**Statement of Compliance
Access for People with a Disability**

**Proposed Residential
Development**

20 Heradale Pde Batemans Bay

Report Type: Statement of Compliance - BCA Access Provisions
Development: 20 Heradale Pde Batemans Bay

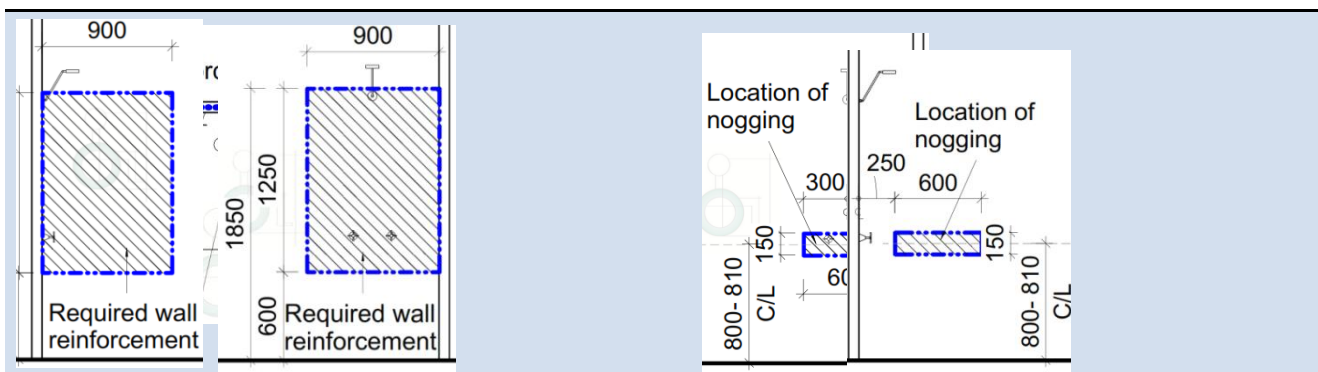
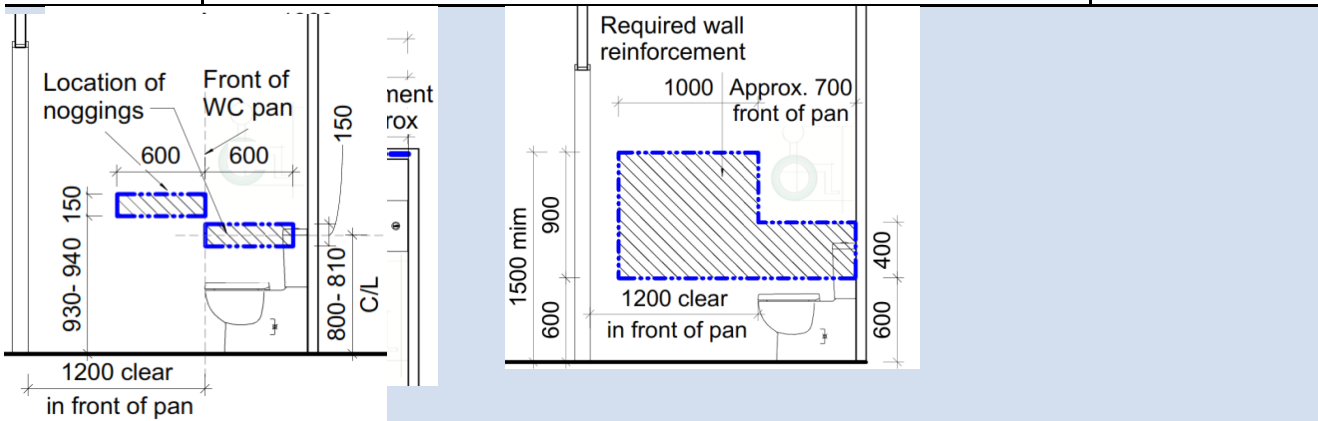
Total number of residential units in the development = 20% of 60 = 12 = **12** required Livable units.

Since **15** of the units already comply with the Adaptable unit requirements, these units are also capable of satisfying the intent of Silver level of Livable Housing Guidelines as noted in the table below.
